North Westerly - PD 2nd Review

To: John Prestwich, PCS Group
From: Aly Burkhalter, Senior Planner
Date: August 16, 2024
Re: PD-001700-2024 North Westerly - PD

2nd Review & Referral Comments

ZONING MAP

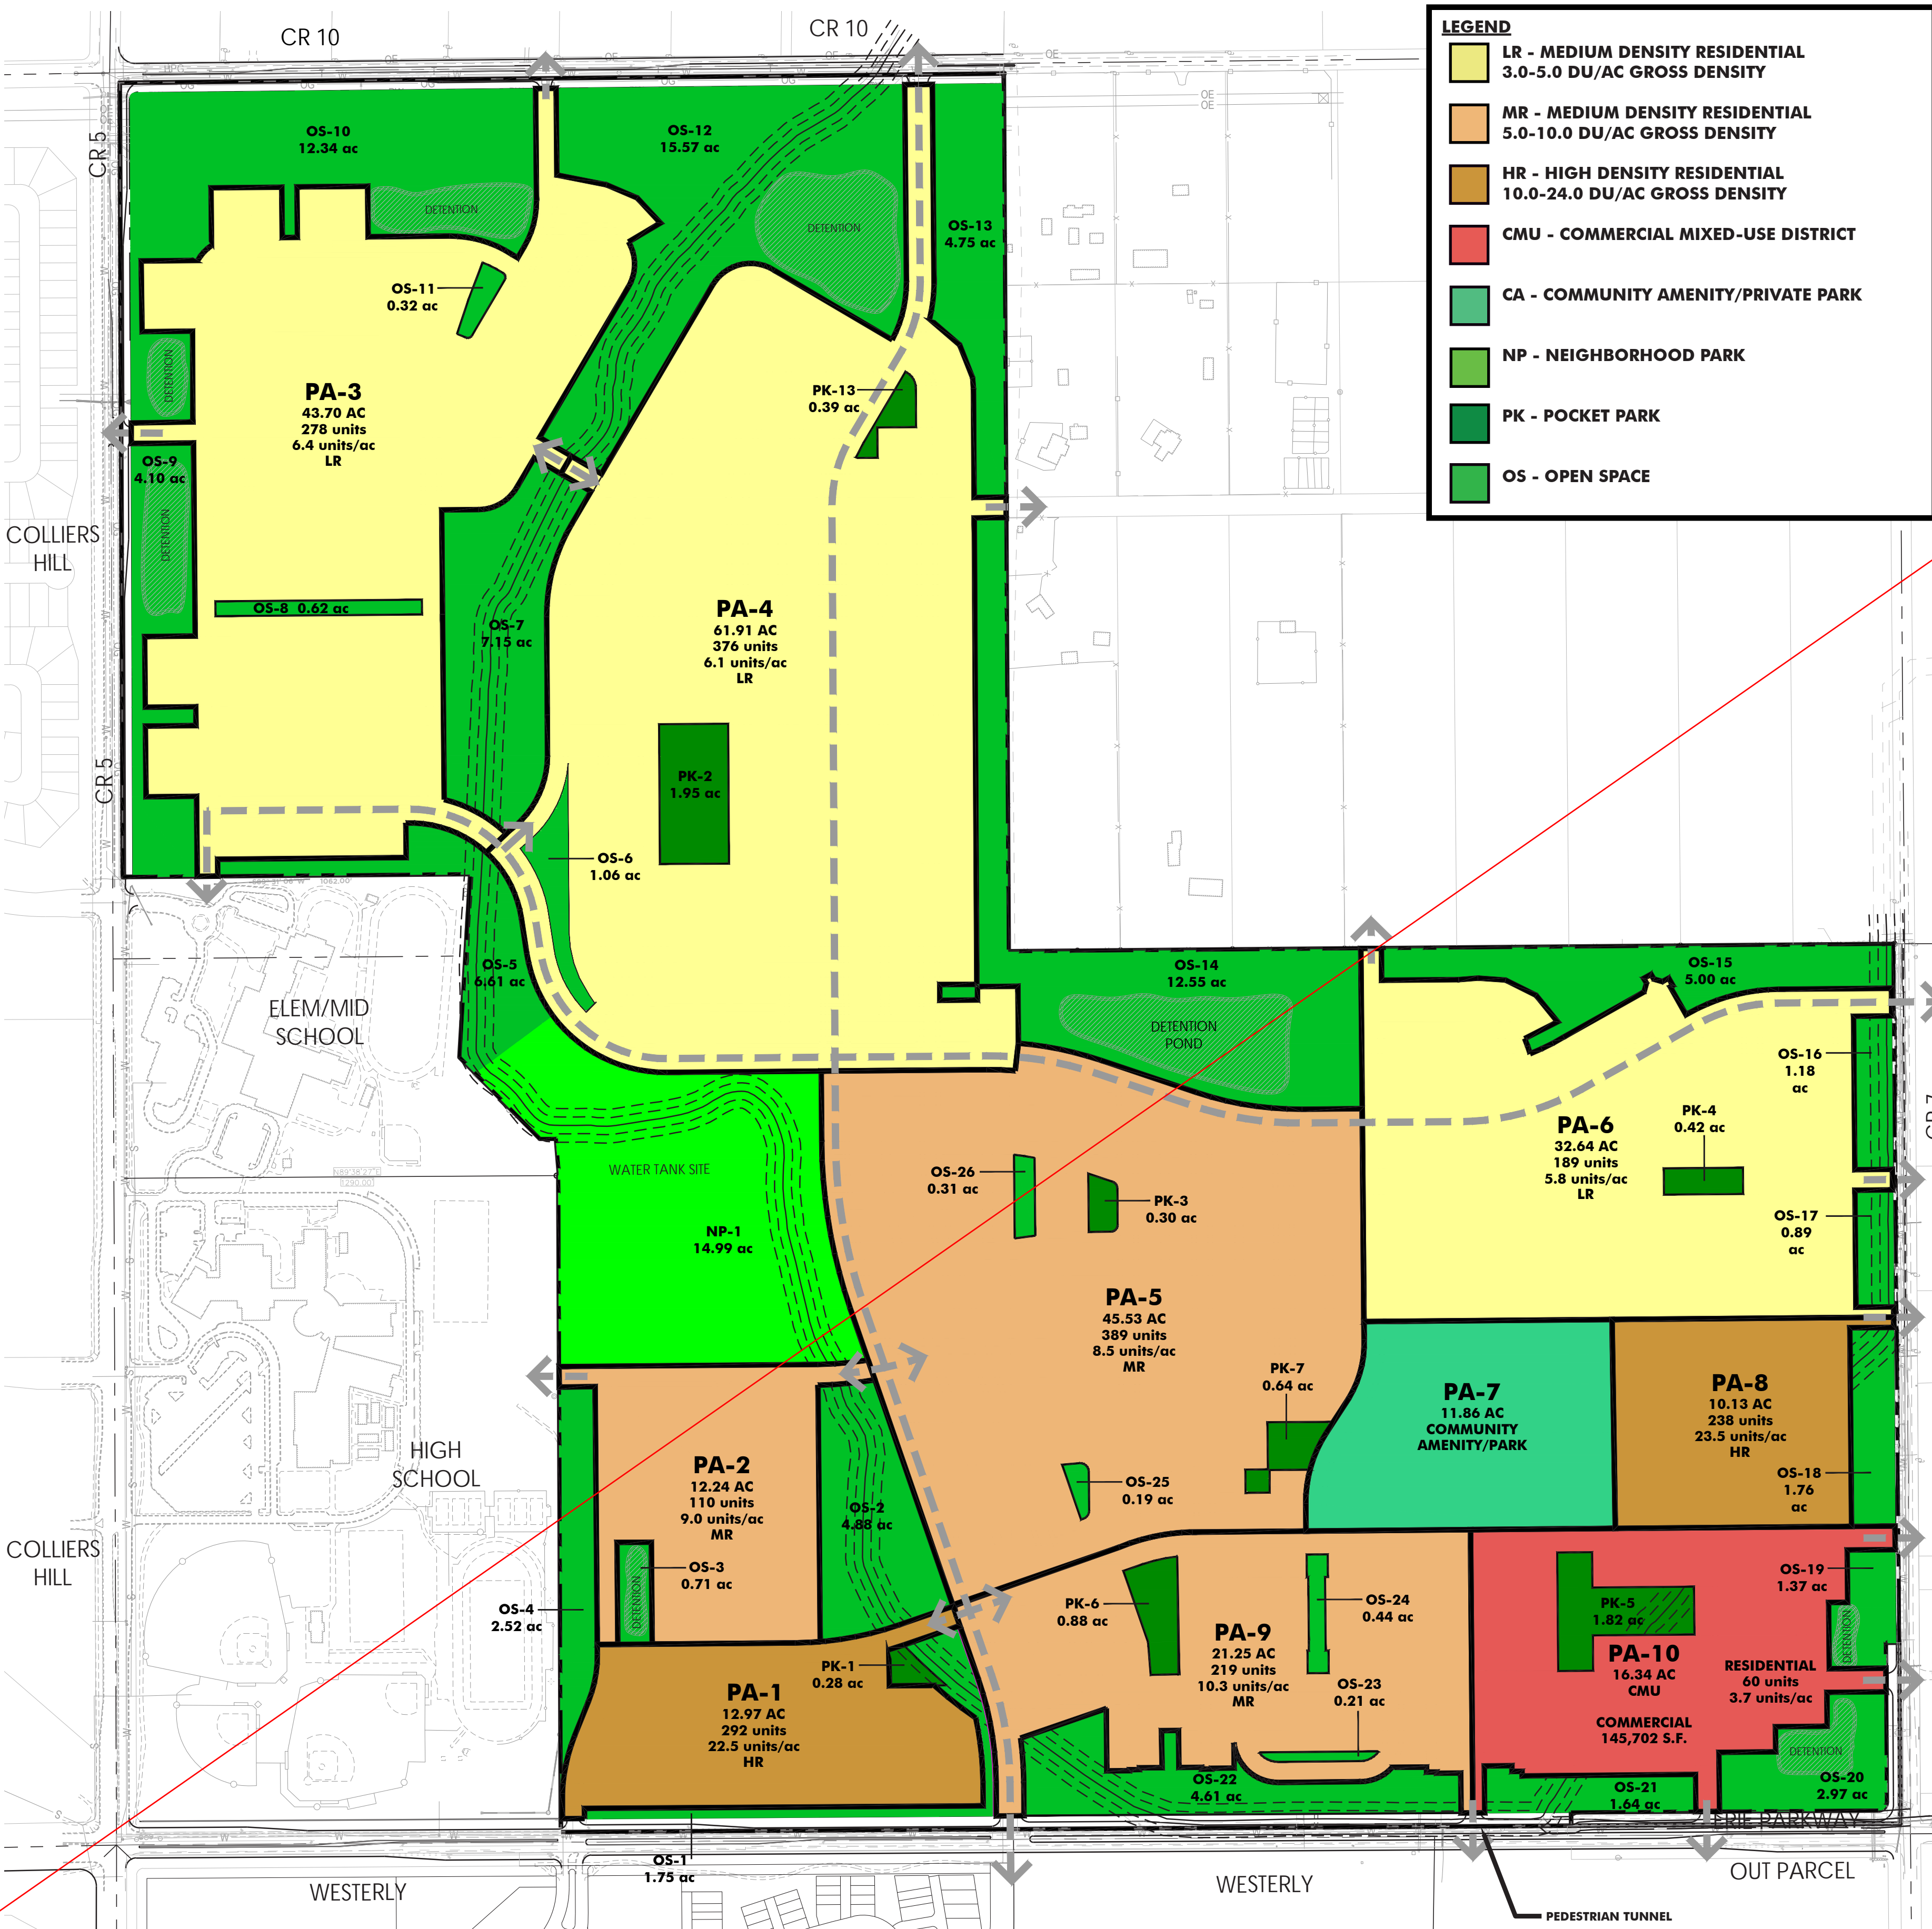
Comment #117a: Zone Map shall show underlying zone district areas (LR, MR, CMU). Community Private Amenity is assumed to be PLI zone district unless applicant demonstrates otherwise. Open Space and Parks land uses will not be their own zone district but included in other zone districts. Legal Descriptions will be provided for each of the underlying zone district boundaries. Zone District boundaries shall be determined based on density ranges of LR/MR/HR, existing zone district boundaries of LR/MR/HR, and future uses to be permitted for PLI/CMU.

STREETSCAPE IMAGE

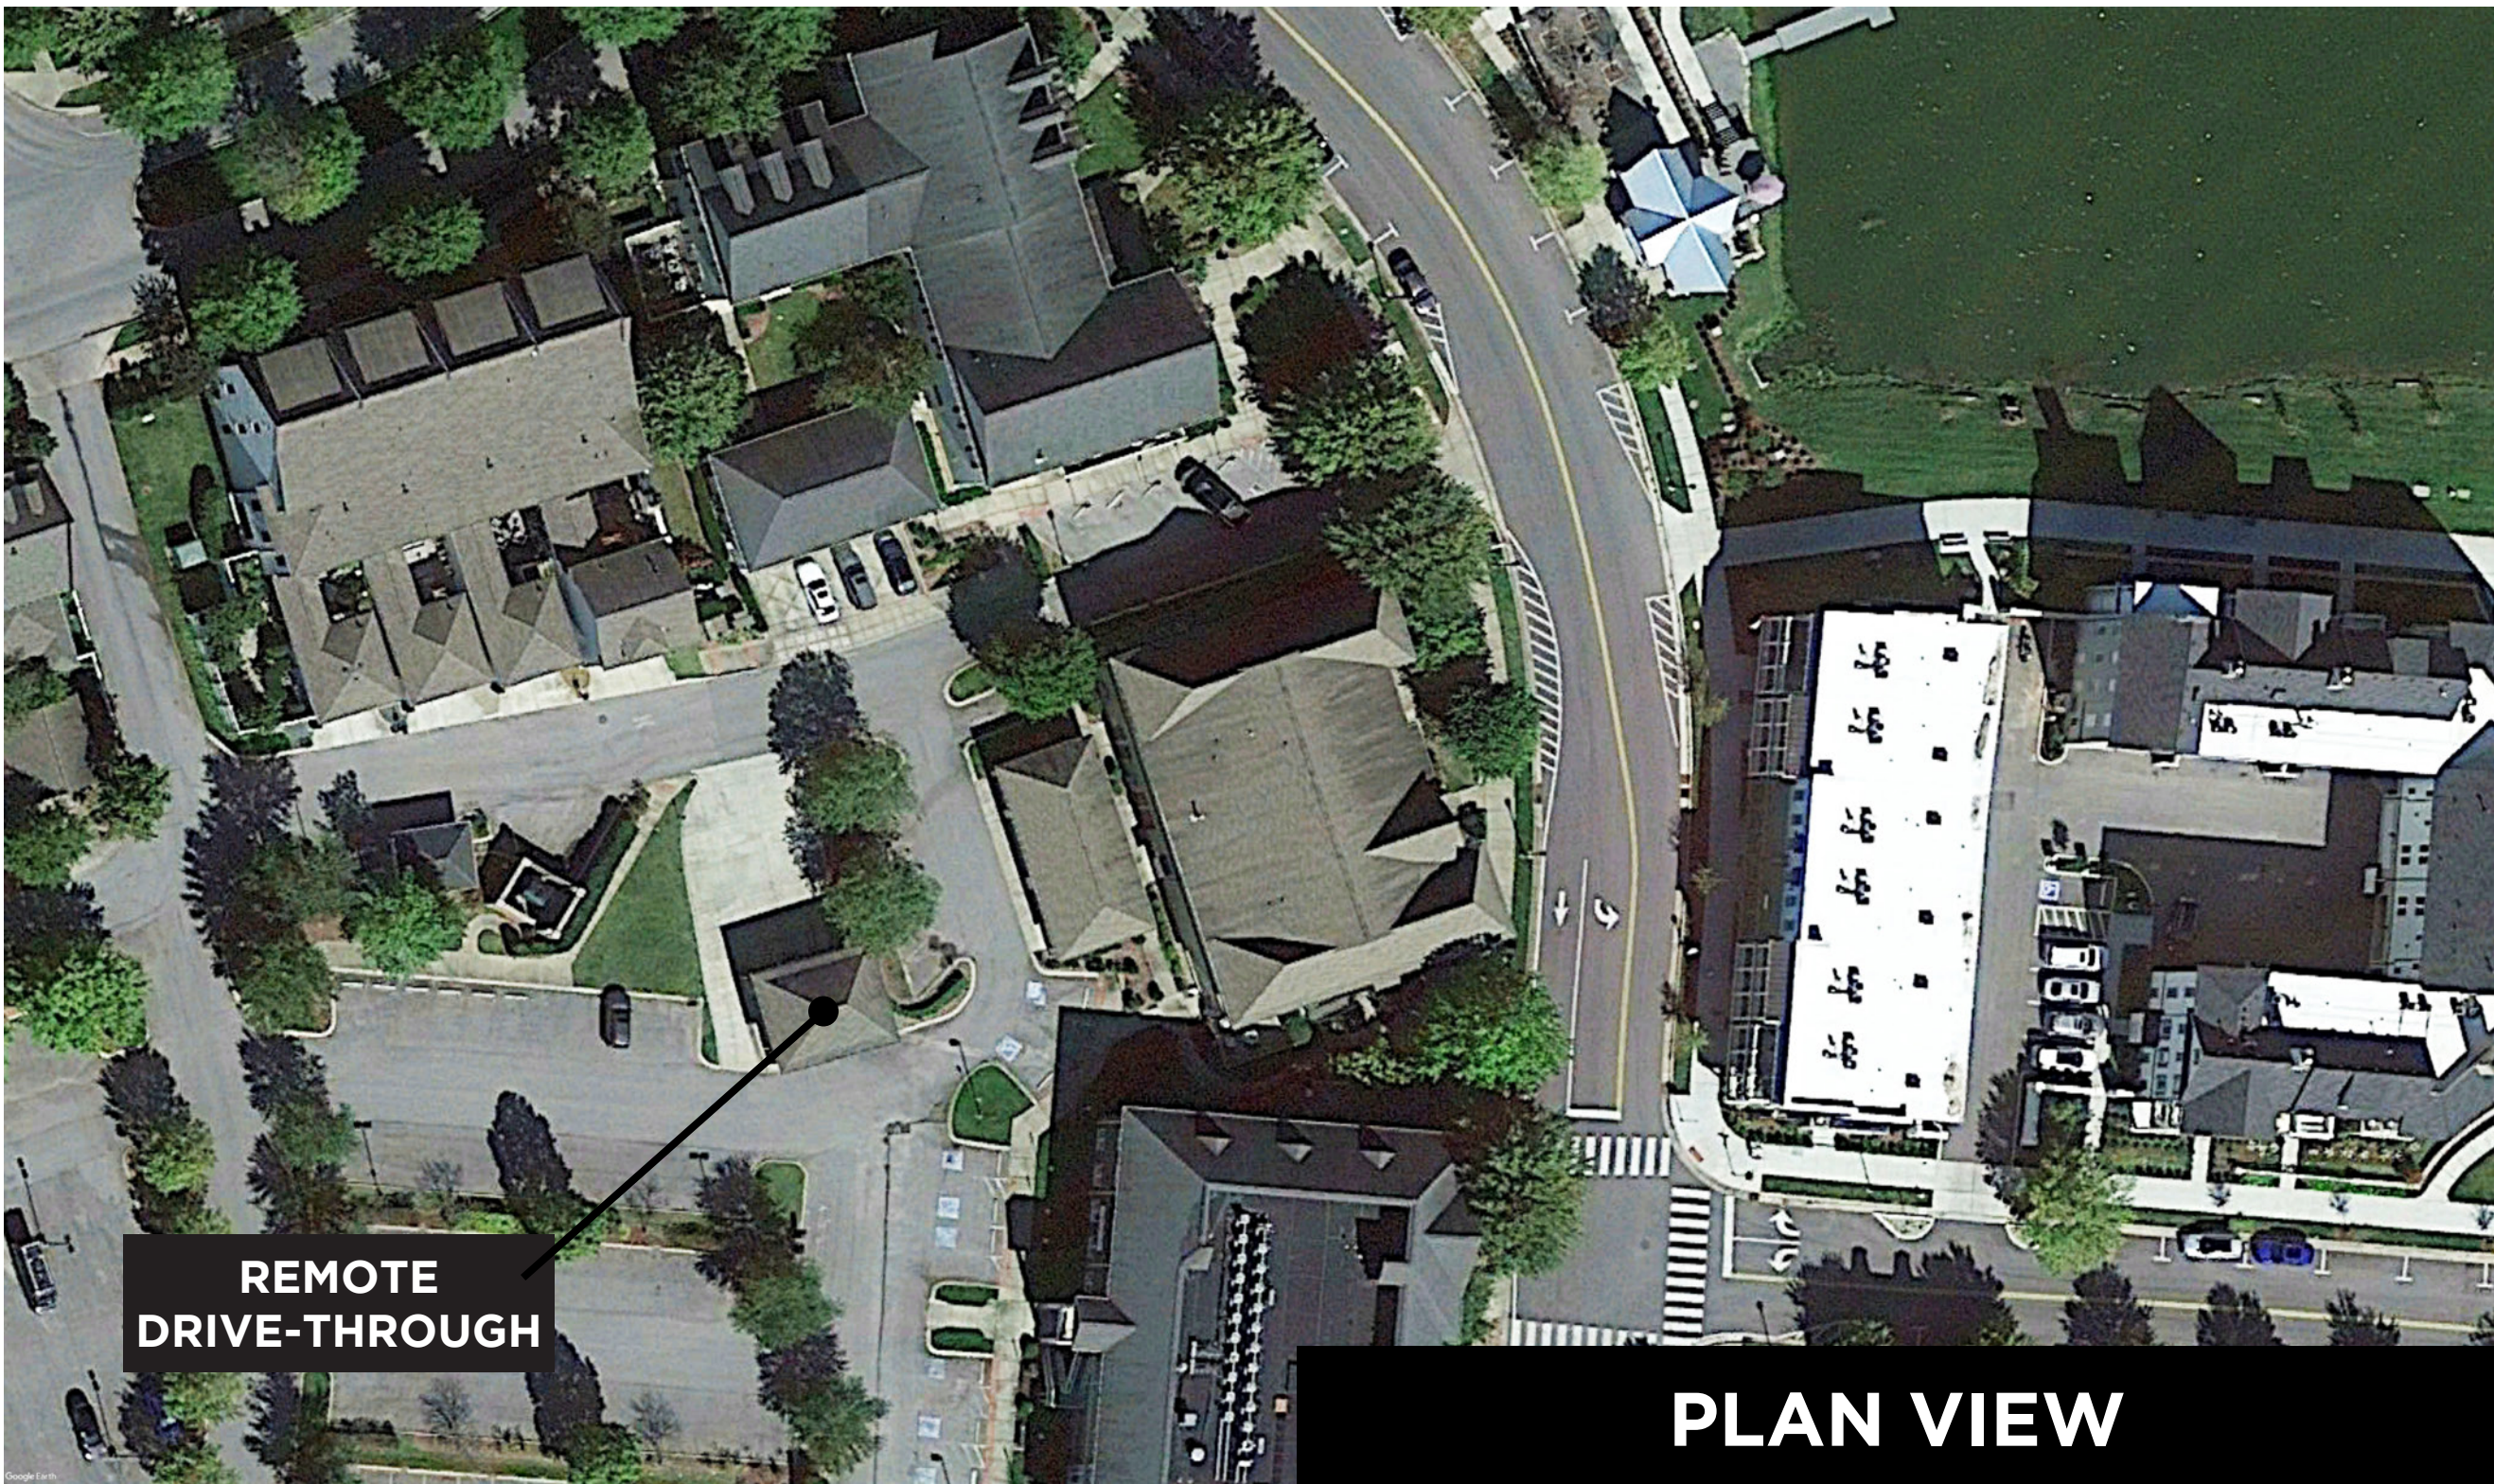
Comment #66: Copy example disclaimer from sheet 9 to sheet 10 to accompany the additional photos: "WE ARE PROVIDING THIS EXAMPLE OF HOW A DRIVE THROUGH FOR A BANK HAS BEEN SUCCESSFULLY INTEGRATED INTO THE PEDESTRIAN COMMERCIAL MIXED USE ENVIRONMENT IN SOUTHERN LANDS WESTHAVEN COMMUNITY"
